ARCHITECTURE PLANNING URBAN DESIGN

August 4, 2022

RE: 14876 Clara Street

Proposed elevation illustrations are shown below.

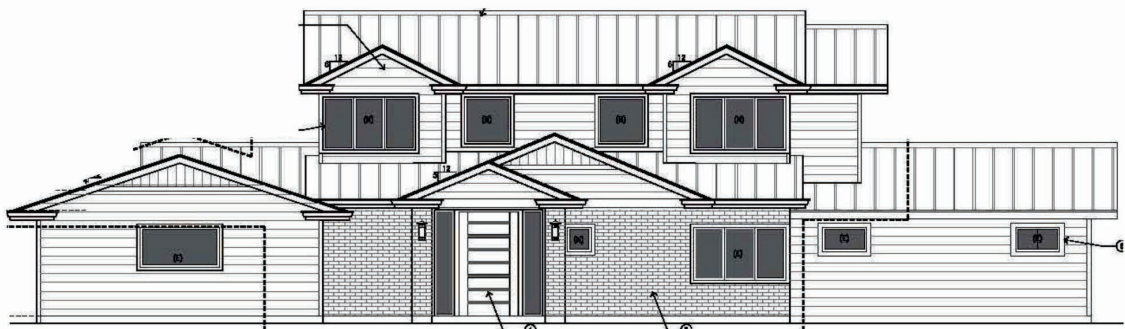
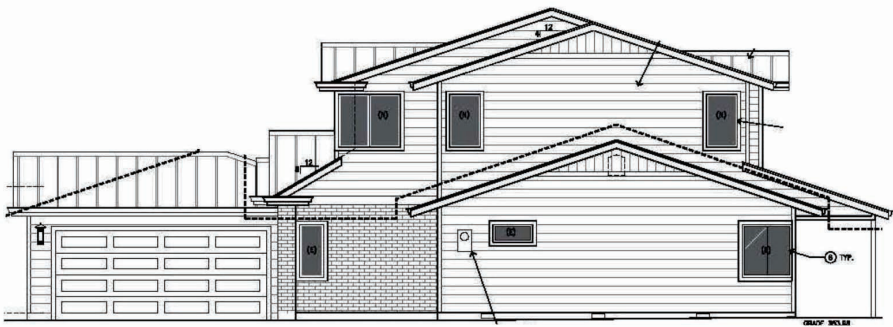
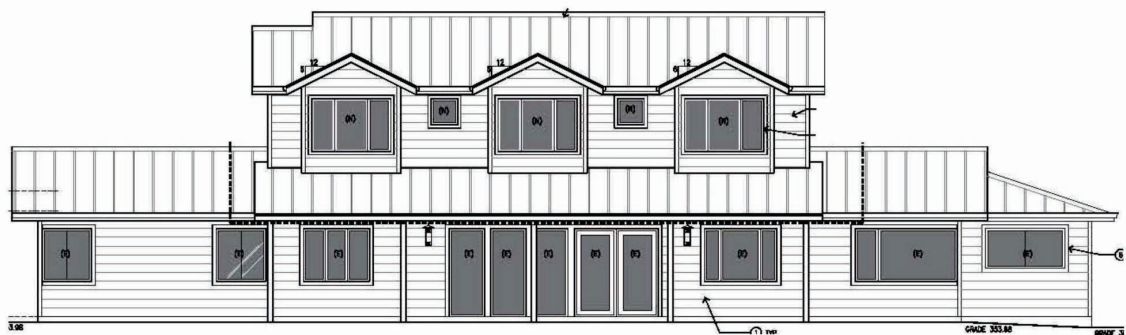
1. The second floor addition appears quite large compared to the existing home and to the surrounding neighborhood homes - see illustration below. Its visual prominence would not be consistent with Residential Design Guideline 2.3.1.

2. The roof slopes shown of the drawings differ which would not be consistent with Residential Design Guideline 3.5.1.

3. The gable eave returns are not consistent with the architectural style.

4. Adding brick on the front facade without repeating it consistently on the other facades would not be consistent with Residential Design Guideline 3.3.2.

- *Avoid large and formal entries unless that is the norm for nearby houses. It is often best to start the design consideration with an entry type (e.g., projecting or under eave porch) that is similar to nearby homes.*
6. Changing garage roof from a hip to a gable may not be the best approach for the overall visual integrity of the design.
7. Changing the first floor eave height and return eave and roof segment are awkward.
8. Off-center windows on the second floor bay projections are visually awkward.
9. Metal roofs would be very prominent and out of character with this neighborhood.

1. Reduce the visual bulk of the second floor addition by utilizing hip roof forms in lieu of gable roofs.
2. Select and maintain a single roof slope for all roofs.
3. Retain the hip roof form on the garage to provide more design unity.
4. Simplify the first floor eaves and provide an under-the-eave entry consistent with the preponderance of surrounding homes.
5. Eliminate the brick facing on the front elevation.
6. Center the second floor front facade windows in the projecting bay facade,
7. Chose a roof material more sympathetic to the surrounding homes. It could perhaps be a composition roof similar to nearby homes or a metal roofing with the look, color and texture of composition roofing.

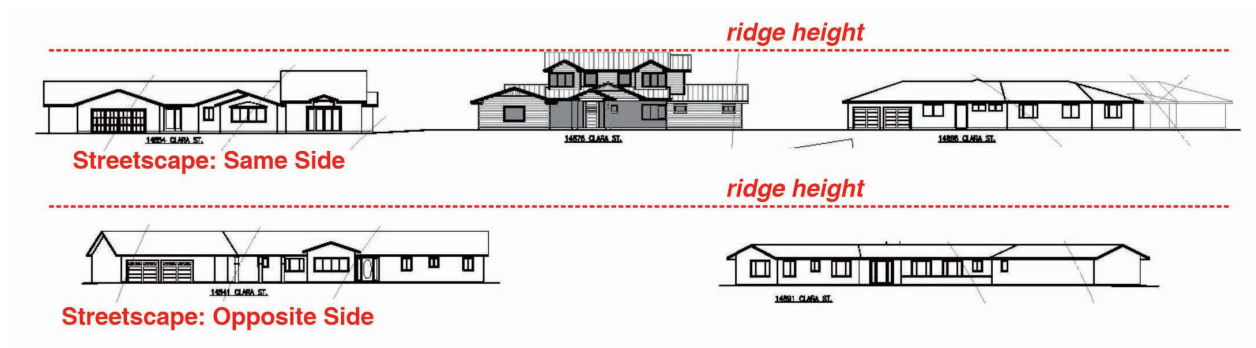
The proposed addition would create the first two-story structure in the neighborhood - see streetscape illustration below.
